S E R V I C E N O T E

HP 8751A Network Analyzer

Firmware upgrade improves performance and corrects known problems described in Table 1.

DATE: 30 November 1992

Figure 1. A1 and A2 Boards

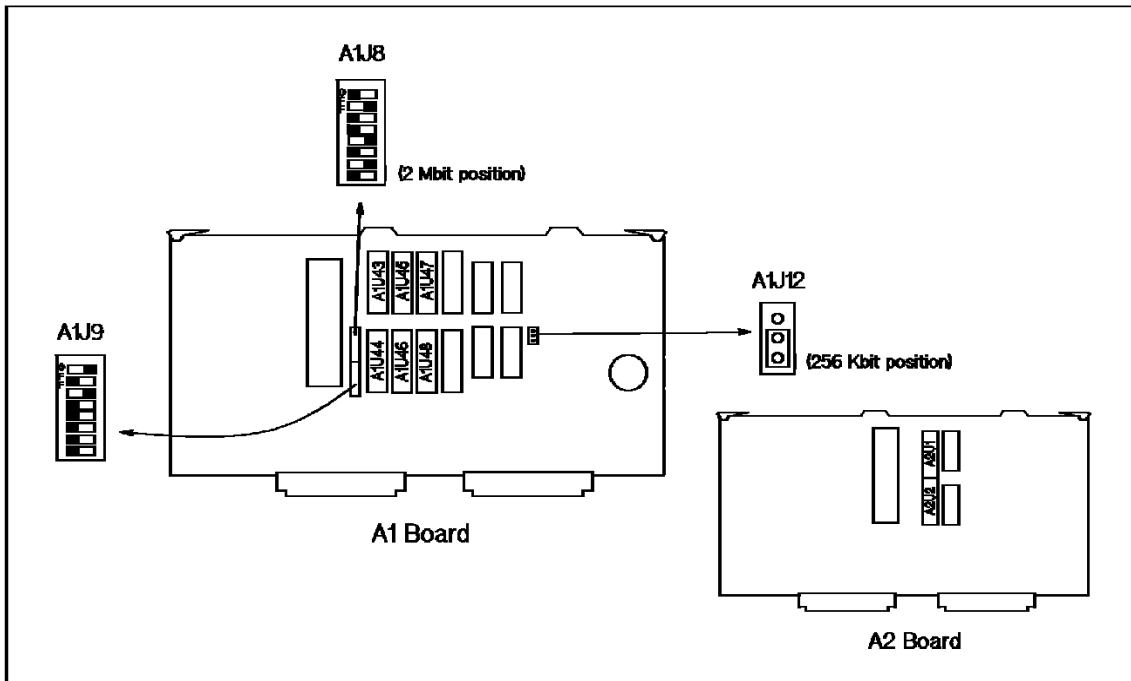
- a. Remove only the A1 board.
 - b. Replace the ROMs of the A1 board with Rev.4.02 ROMs. Table 2 and Figure 1 show the ROM locations.
4. If the revision is "Rev.3.xx" and below,

- a. Remove the A1 and A2 boards.
 - b. Replace the ROMs of the A1 and A2 boards with Rev. 4.02 ROMs. The ROM locations are shown in Table 2, Table 3 and Figure 1.

- c. Figure 1 shows the jumper and bit switch settings for Rev. 4.02. In case of any difference, replace RAMs and change the switch settings by referring to the Modification Note (P/N 08751-90034).

The problems listed in Table 1 are fixed with firmware revision 4.02 and above. Replace six ROMs on the A1/A2 boards with new ROMs,
